# Technical Service Information

## TOYOTA A240 HARSH 1-2 SHIFT (CLUTCH MATERIAL)

Figure 1

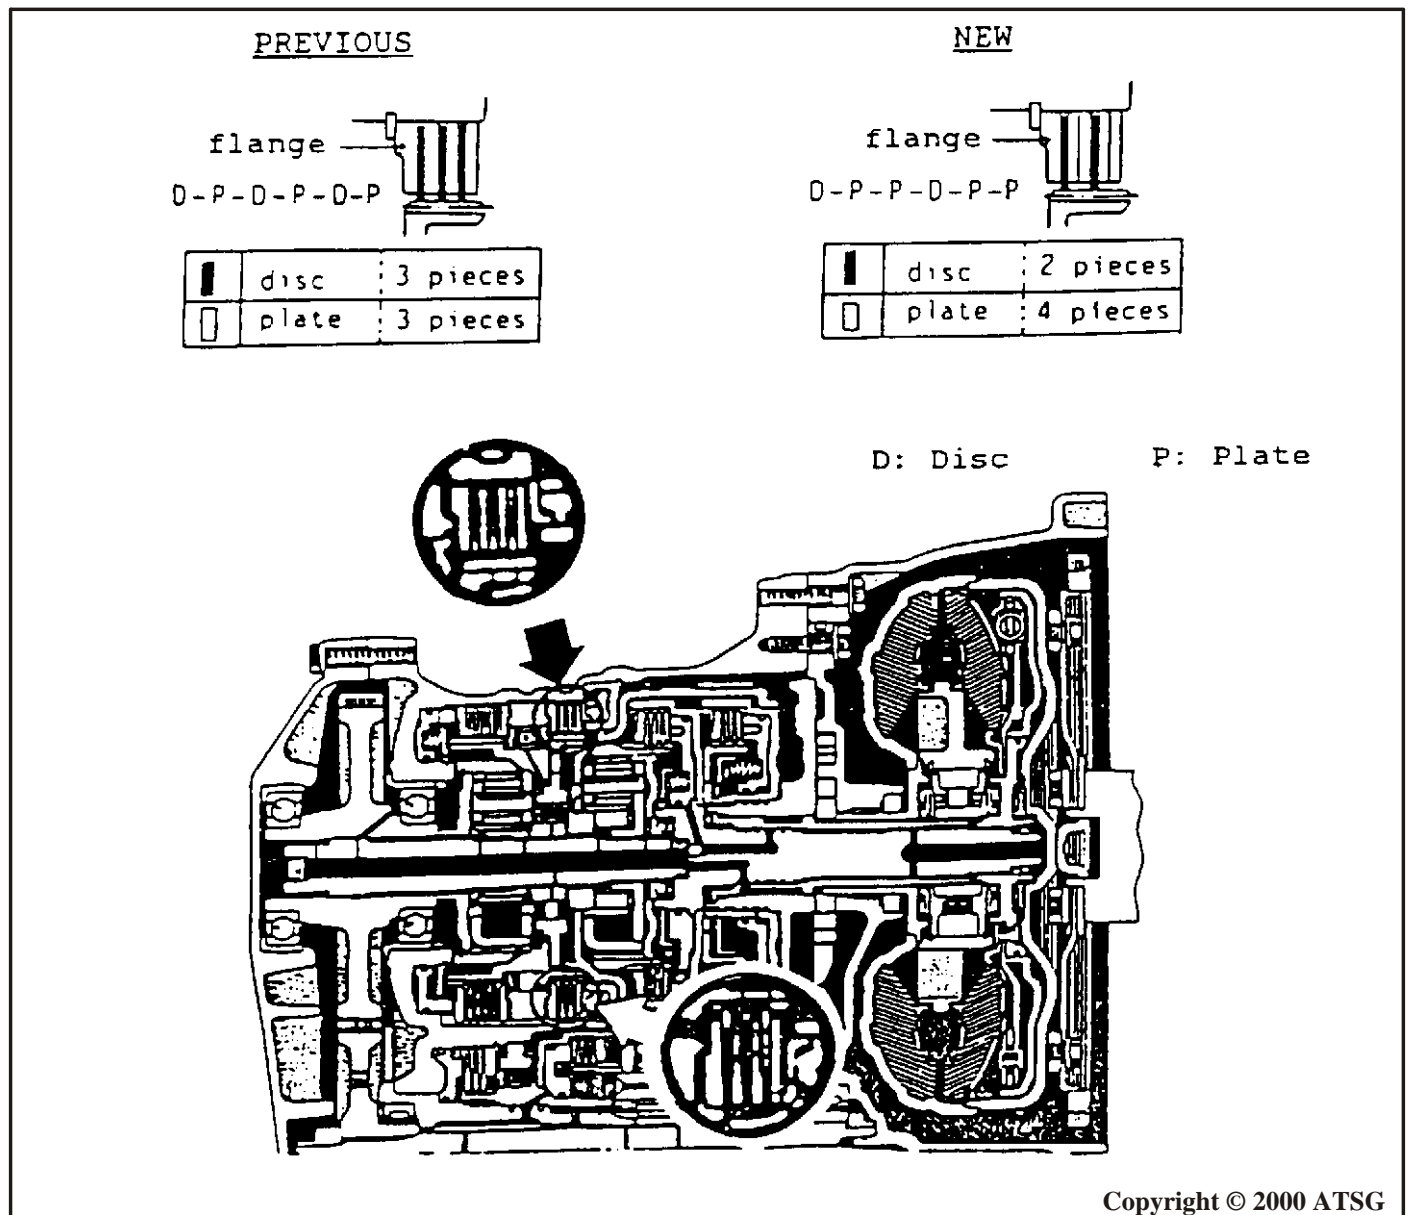
To reduce the shift shock levels on MR2's and Corolla's equipped with A240 automatic transaxles the following changes have been made,

1. Friction material of B2 disc has been changed.
2. The number and order of B2 disc and plates has been changed. (See illustration)
3. B2 Accumulator Piston Spring has been changed

<u>PREVIOUS PART #</u>	<u>Q'TY</u>	<u>NEW PART #</u>	<u>Q'TY</u>	<u>PART NAME</u>
35677-12010	3	*35677-20020	2	DISC, CLUTCH. (For 2nd Brake)
35648-32010	3	*SAME	4	PLATE, CLUTCH (For 2nd Brake)
90501-25011	1	*90501-26014	1	SPRING (B2 ACCUMULATOR PISTON)

\* PARTS ARE INTERCHANGEABLE AS A SET ONLY
